ENDL TEXAS

Date: 1 March 2008
To: T10 Technical Committee
From: Ralph O. Weber
Subject: SPC-4 UML Conventions and CbCS UML Updates

Figure 11 — CbCS overview class diagram

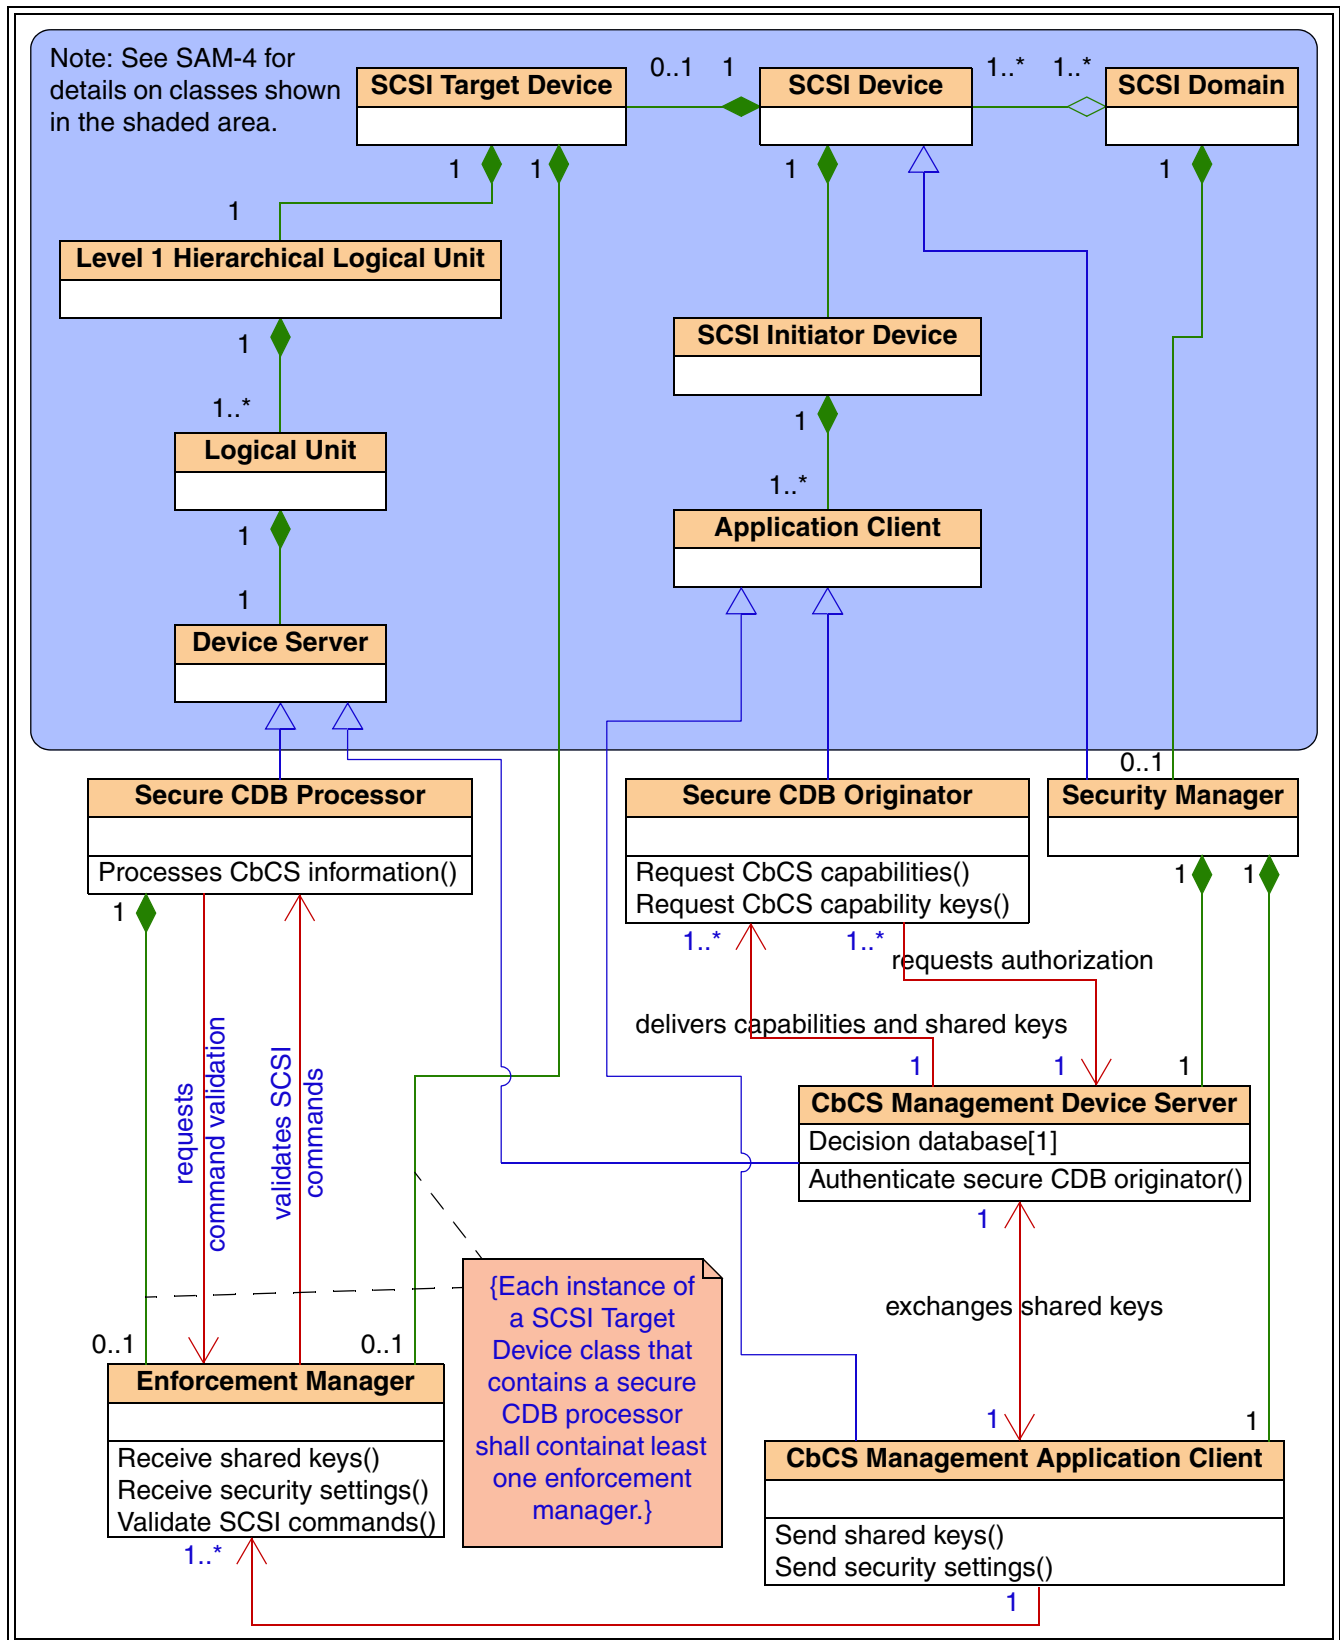
Also, the CbCS UML lacks the required multiplicity notations, and they are proposed here.

- r0 Initial revision
- r1 Revised figure 11 (CbCS overview class diagram) as requested by Sivan Tal and George Penokie. Since change bars do not effectively identify changes in figures, no change bars were added in r1

Except for figure 11, all changes in this proposal represent new SPC-4 text. In figure 11, additions are shown in blue text, there are no deletions proposed. Comments are shown in green text.
